MSOE – SCIENCE RENOVATIONS
CONSTRUCTION BULLETIN**Bid Set – CB-004**

R/S # 22-129
Date: 06/10/2025
To: VJS Construction Services
W233 N2847 Roundy Circle West
Pewaukee, Wisconsin, 53072

A. Intent of this Construction Bulletin is in response to DPW comments/requested revisions.

C201.1

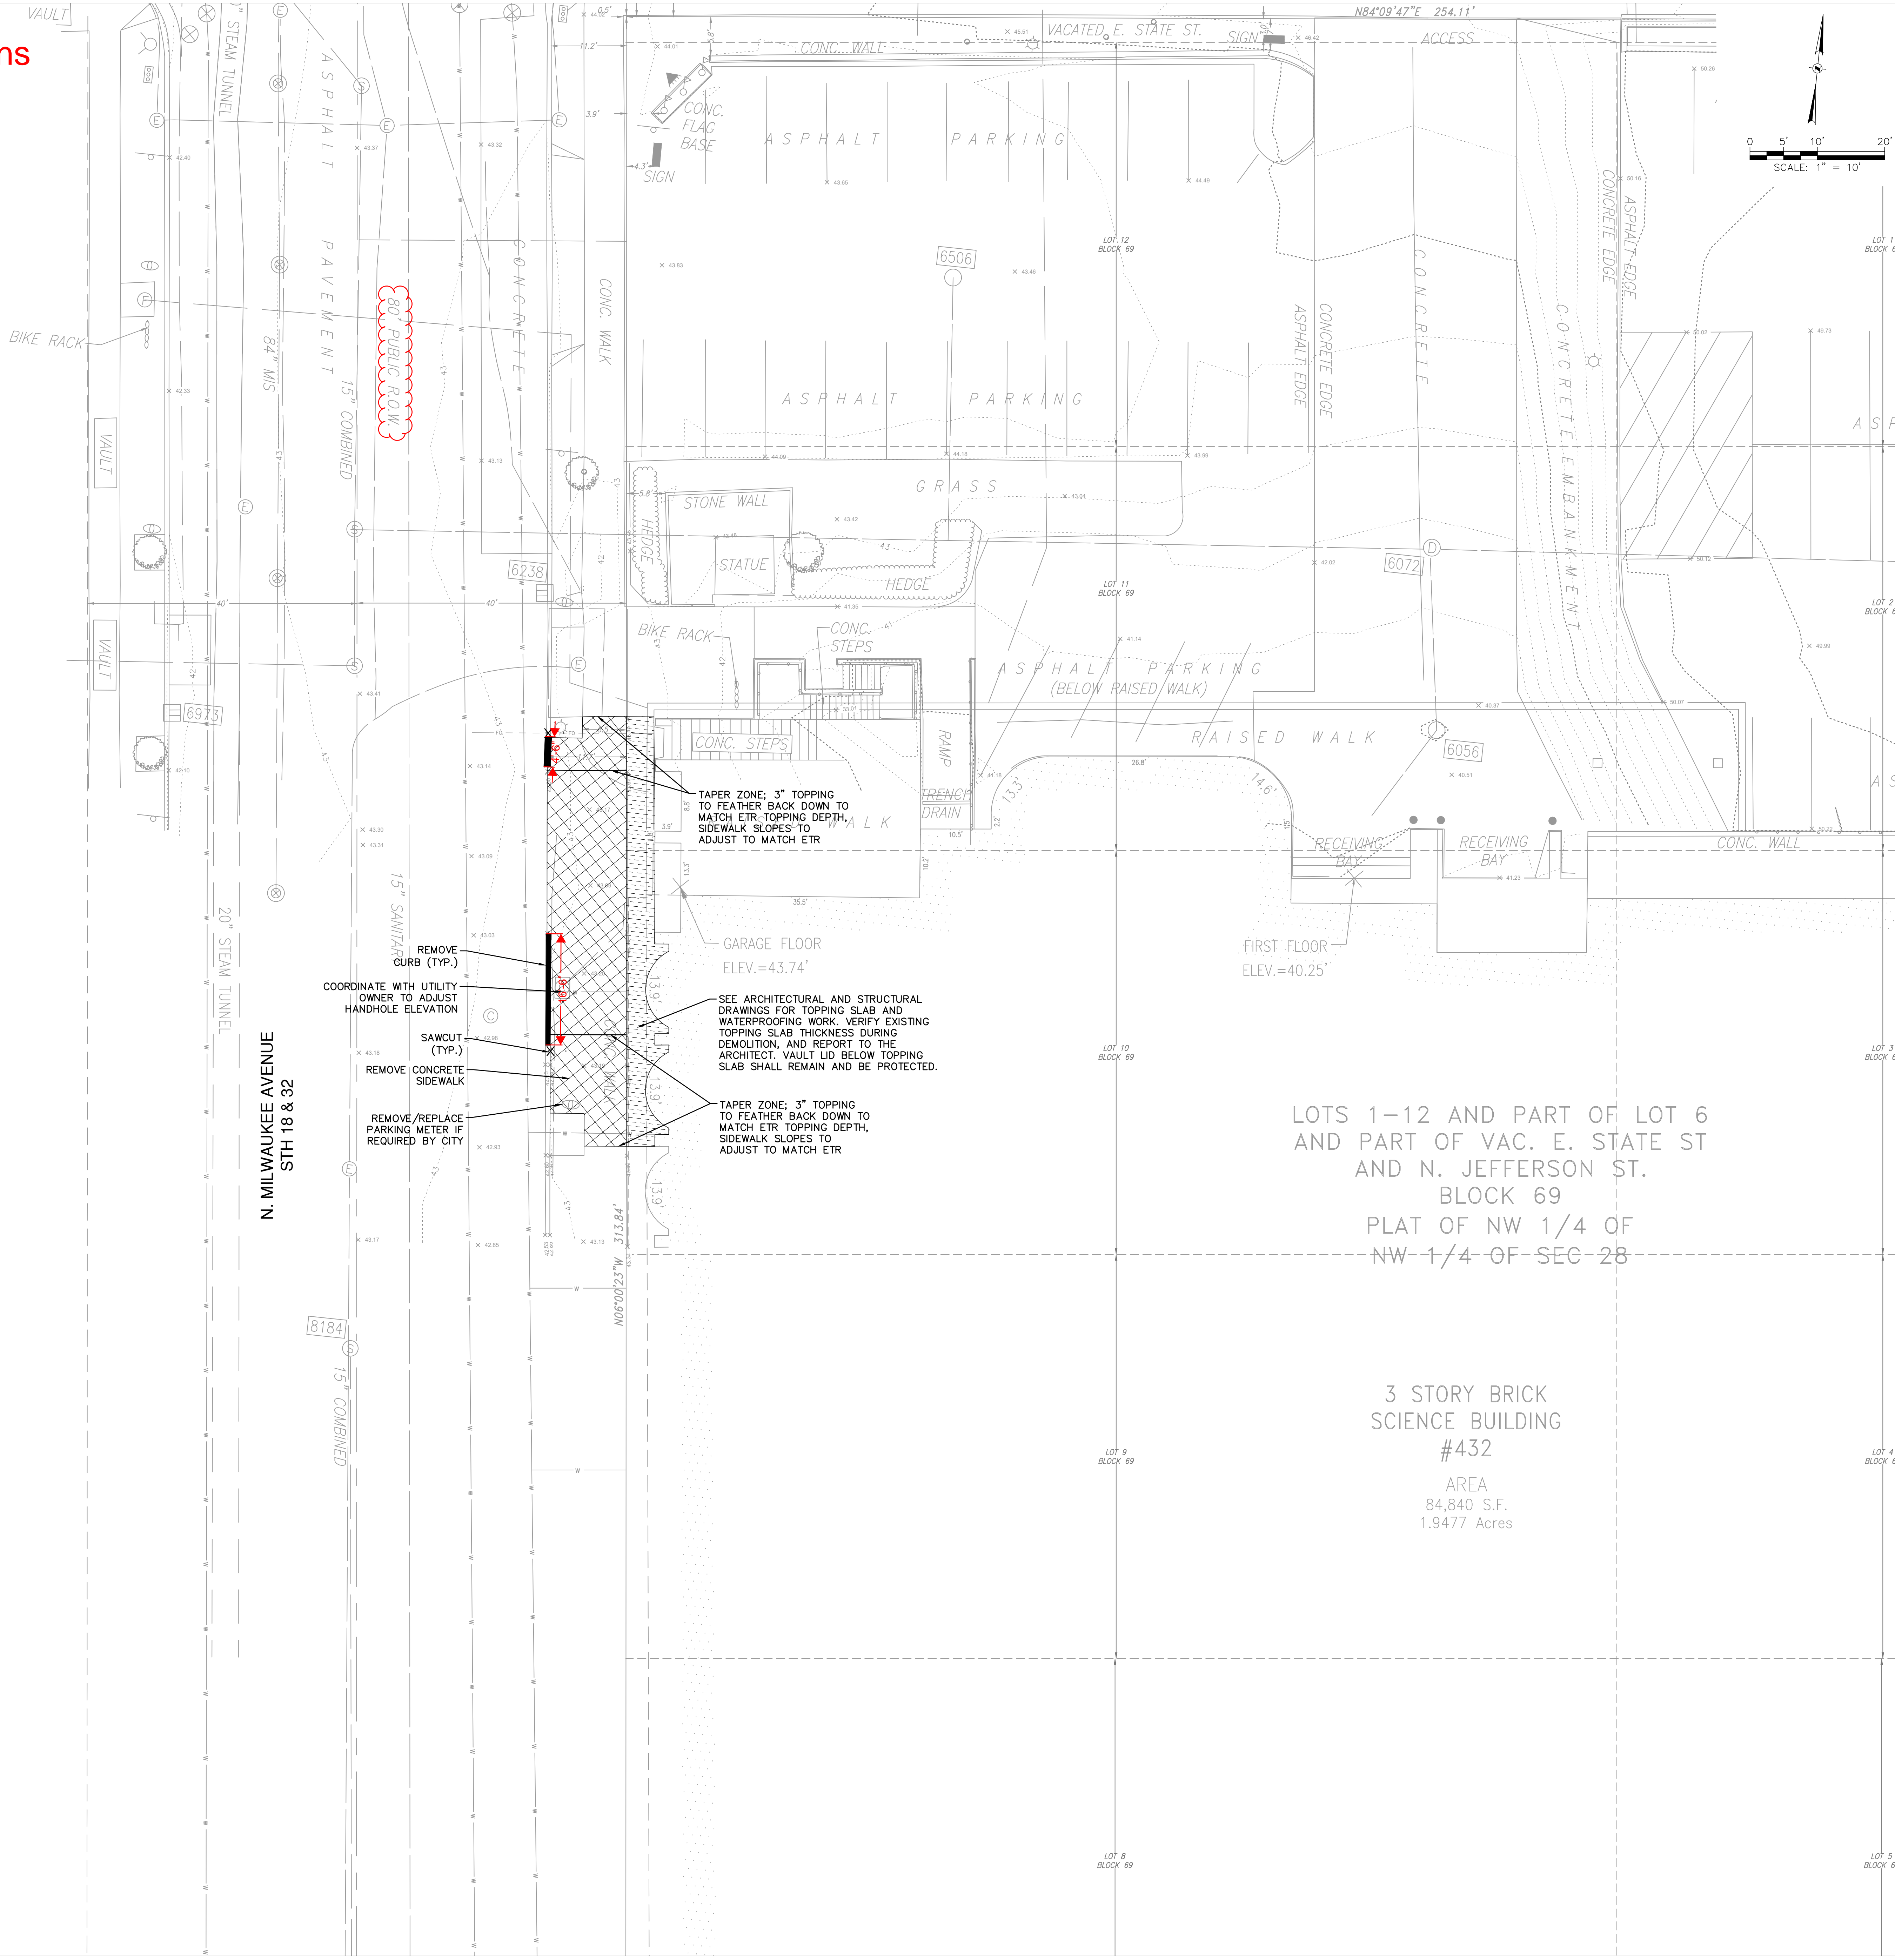
1. Revised North sidewalk taper zone based on DPW comments.

C301.1

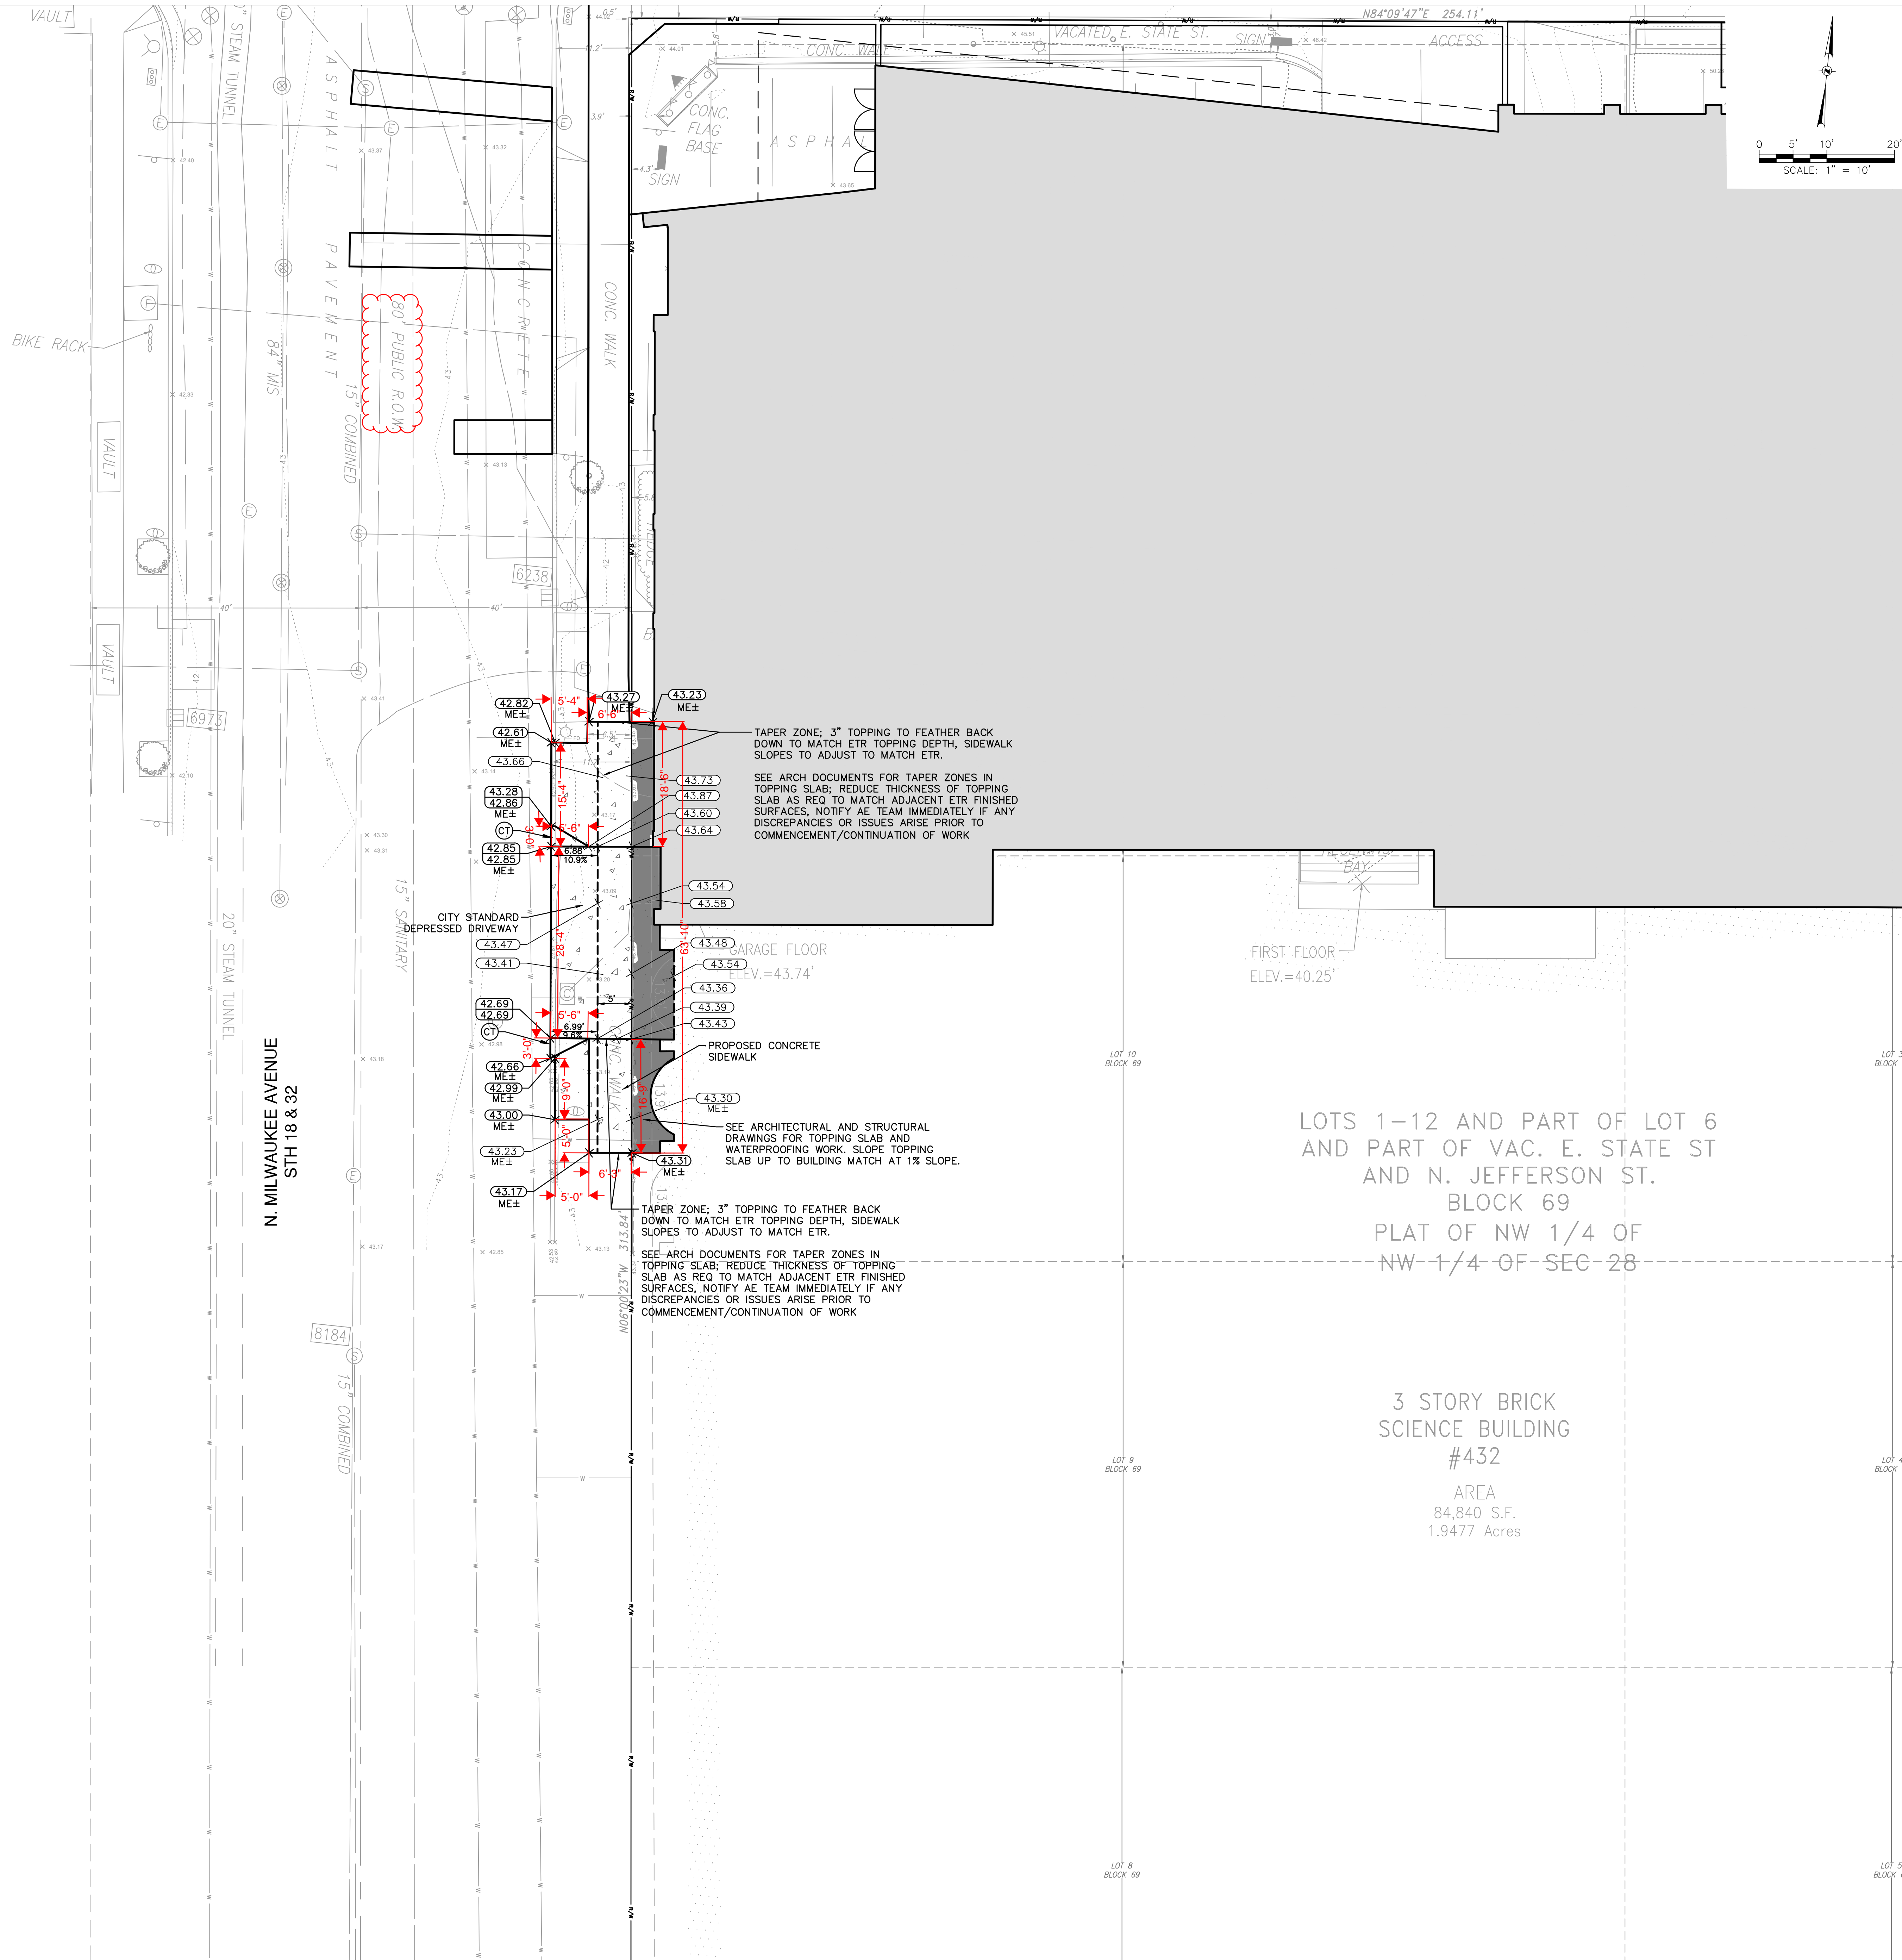
1. Revised North sidewalk taper zone based on DPW comments.
2. Revised ADA walk surface location and associated grades as necessary.
